# SANITARY SEWER TO SERVE Fantasea II Addition Part of Lot 2, Block 1 2214 PPS (607861) CITY OF WICHITA, KANSAS Gary Janzen, P.E., City Engineer

AS BUILTS	
Contractor: Wichita Excavation 5/14/2015	Project Inspector: Larry Gann  <b>KEMILLER</b> ENGINEERING PA 117 E. Lewis, Wichita, KS 67202 (316)264-0242

# AS BUILTS

Rushpointe Apartments, LLC  
Plan and Profile  
Wichita, Kansas

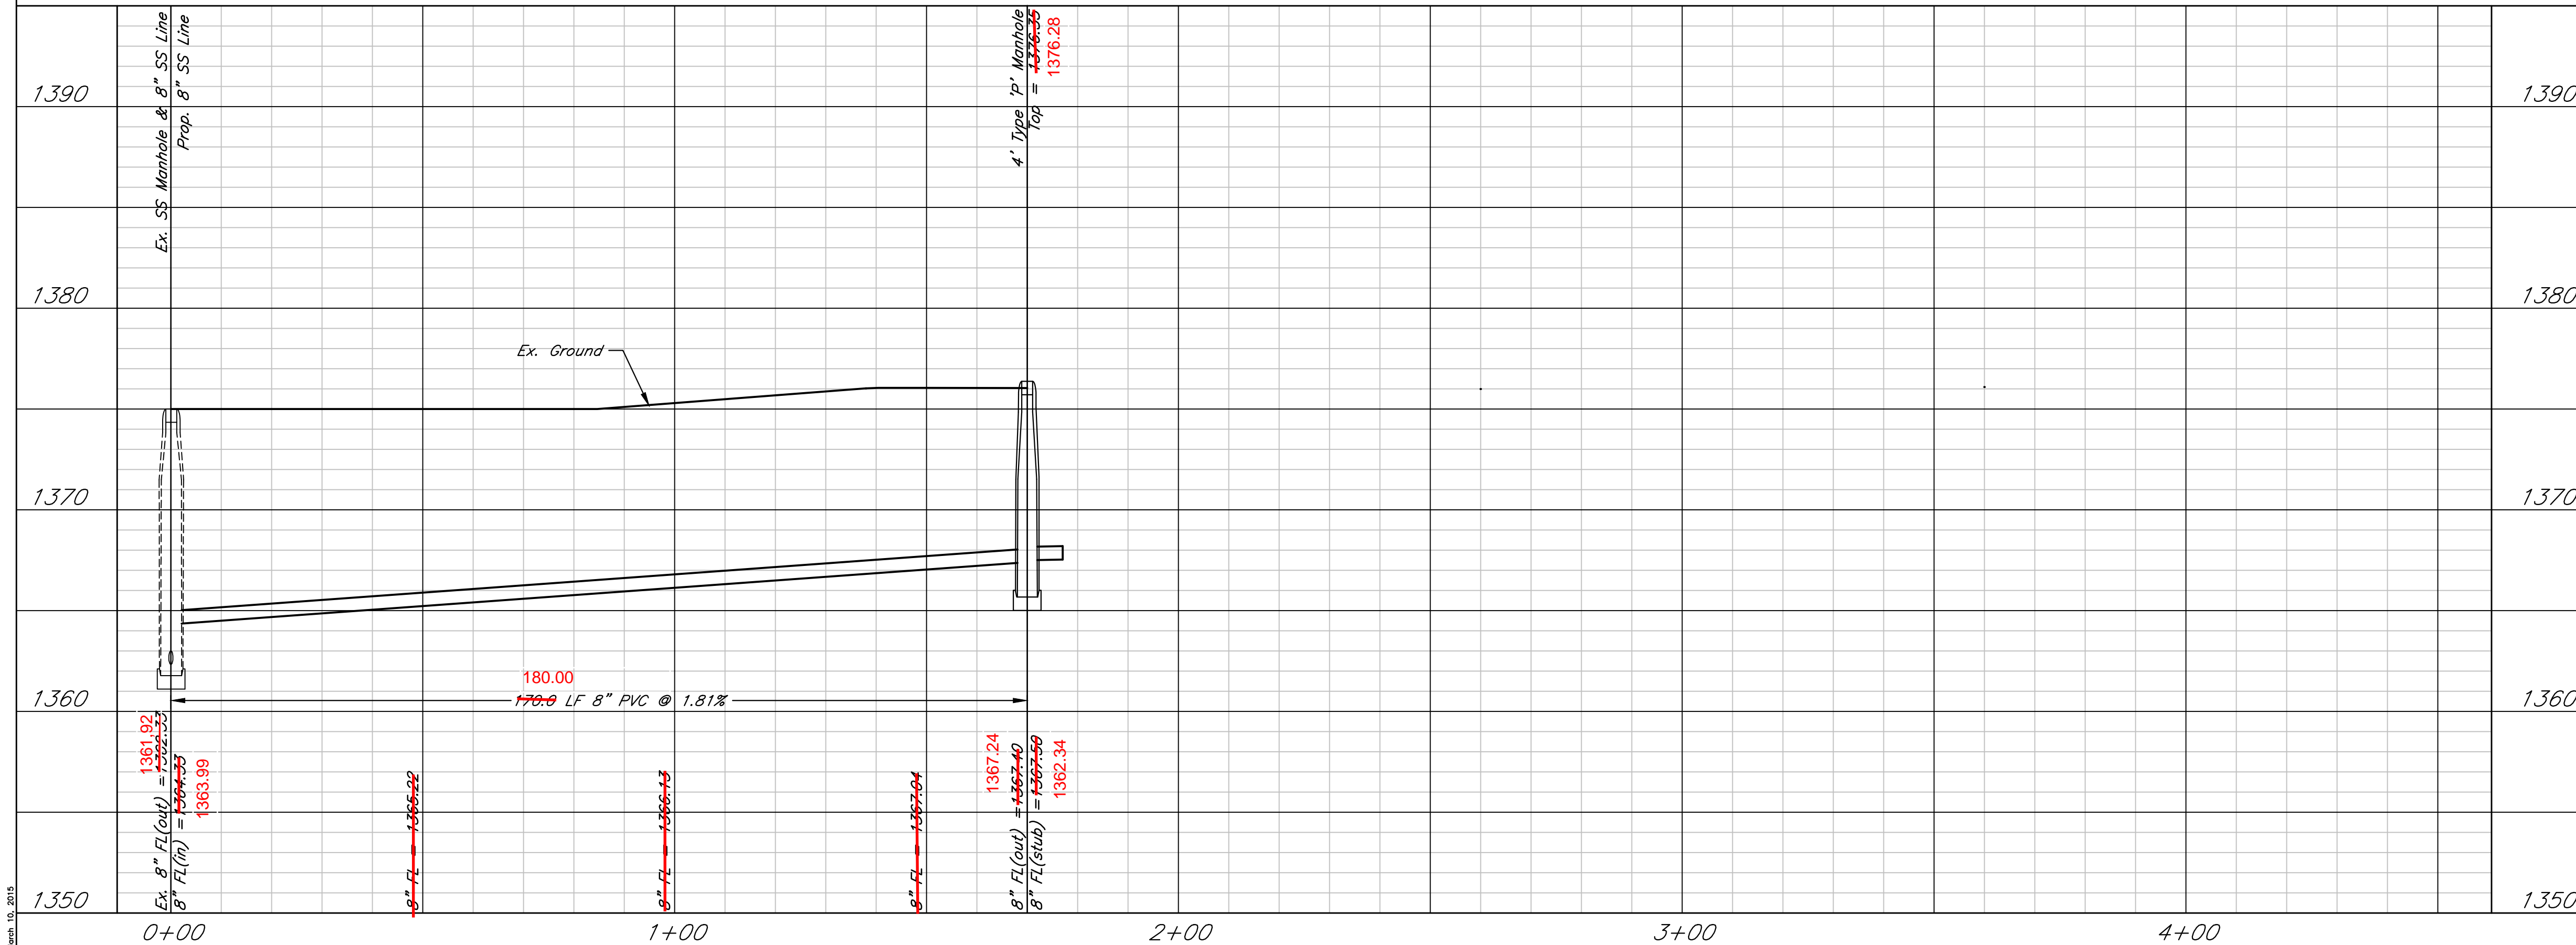
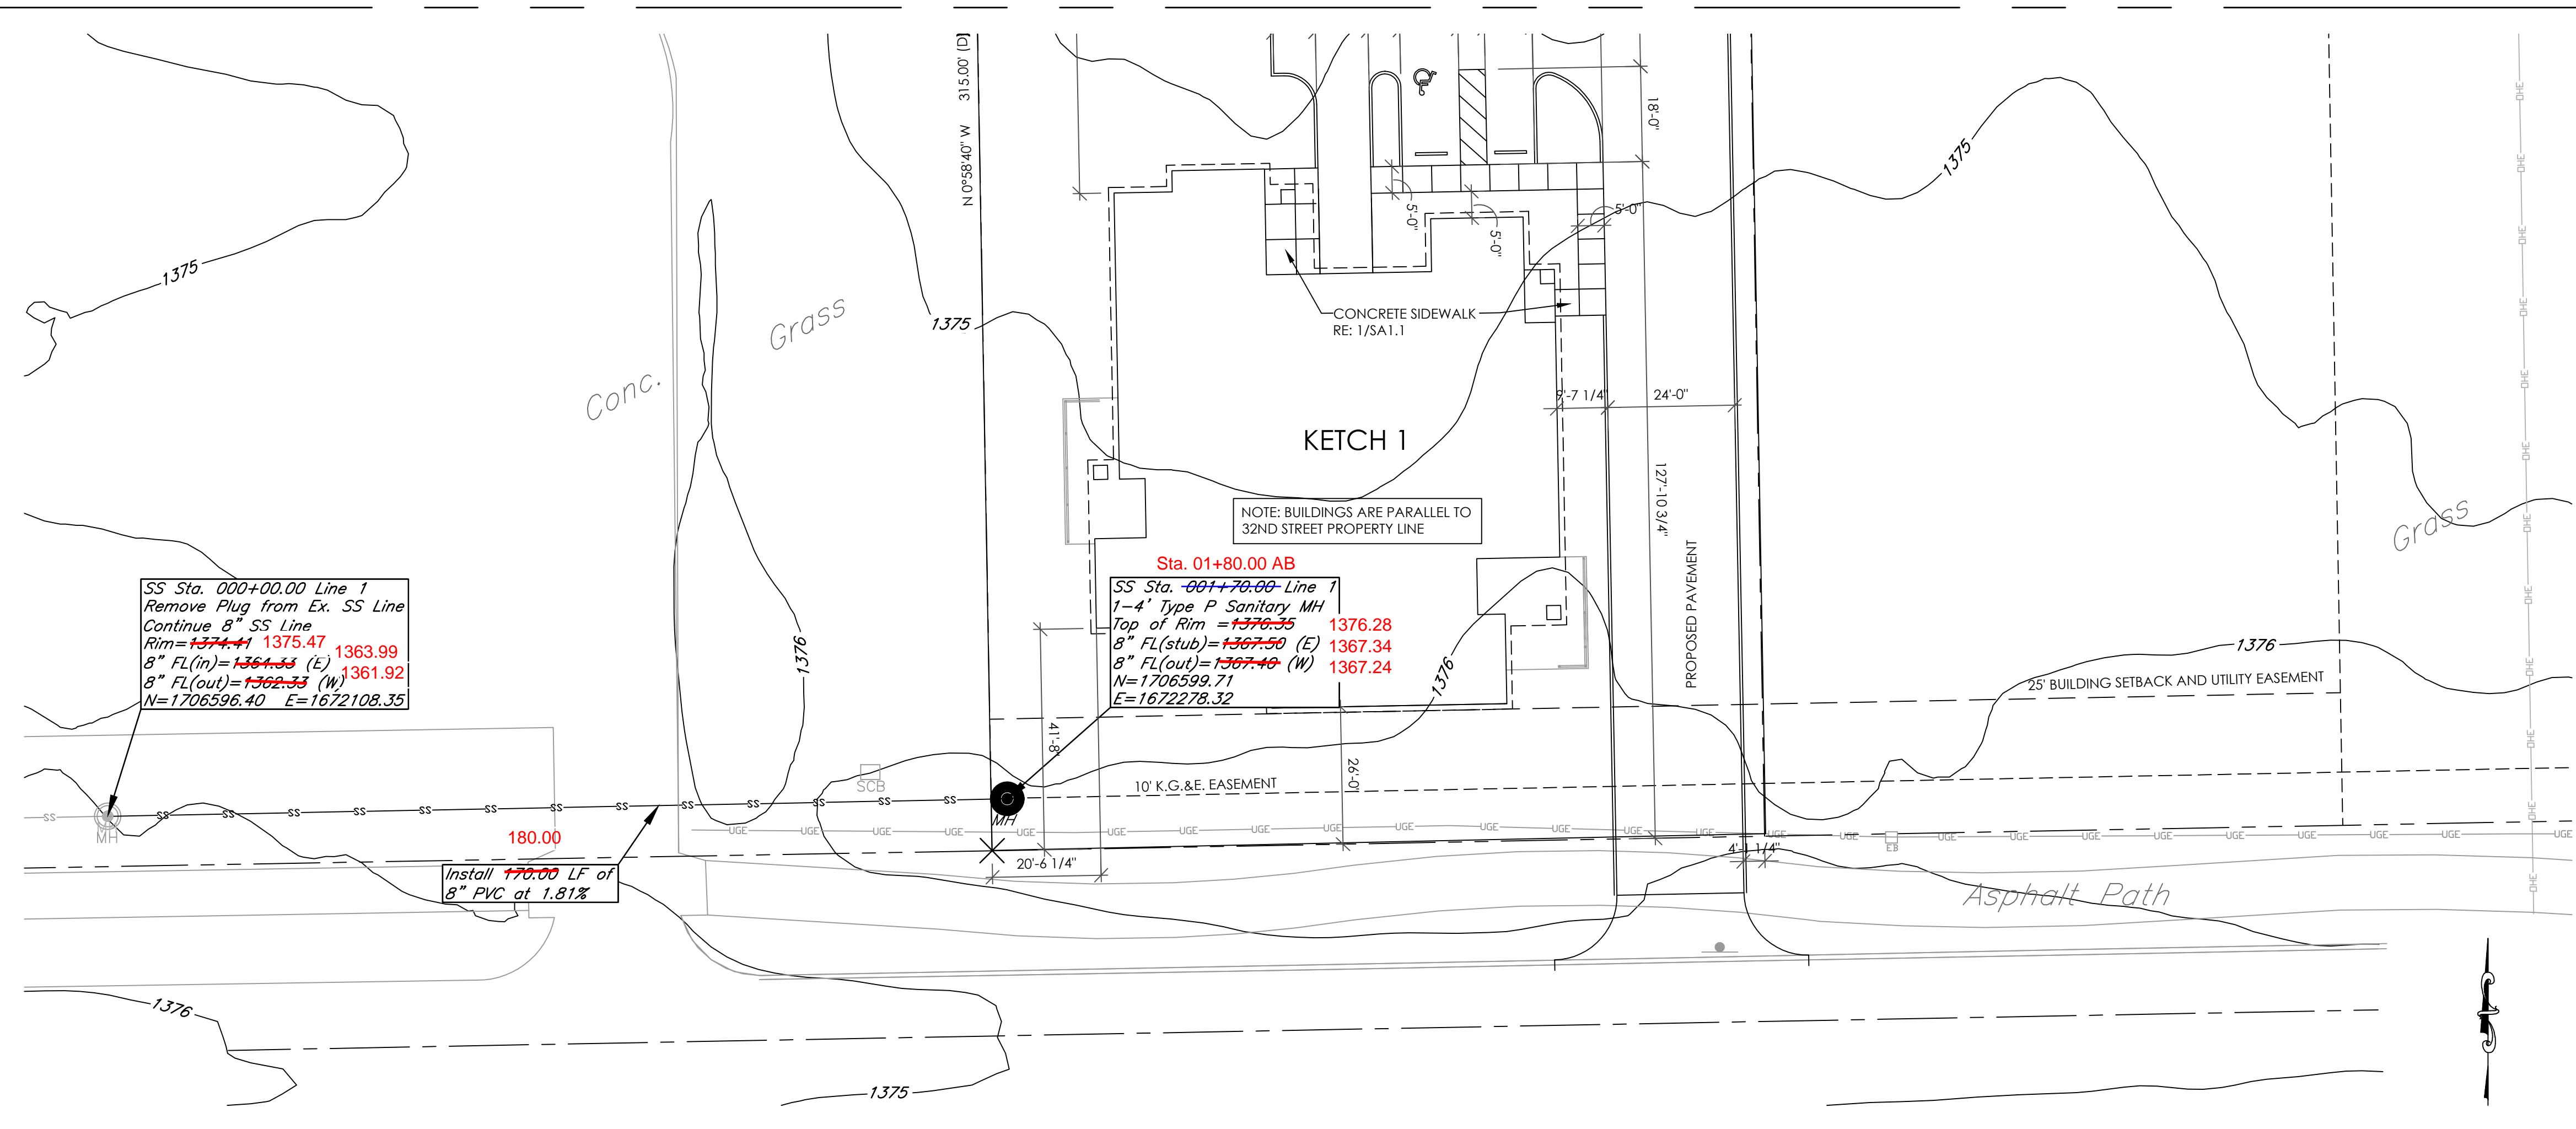
SS Sta. 000+00.00 Line 1  
Remove Plug from Ex. SS Line  
Continue 8" SS Line  
Rim = ~~1374.41~~ 1375.47 1363.99  
8" FL(in) = ~~1364.33~~ (E) 1361.92  
8" FL(out) = ~~1362.33~~ (W) 1361.92  
N=1706596.40 E=1672108.35

Sta. 01+80.00 AB  
SS Sta. 001+70.00 Line 1  
1-4' Type P Sanitary MH  
Top of Rim = ~~1370.35~~ 1376.28  
8" FL(stub) = ~~1367.50~~ (E) 1367.34  
8" FL(out) = ~~1367.40~~ (W) 1367.24  
N=1706599.71 E=1672278.32
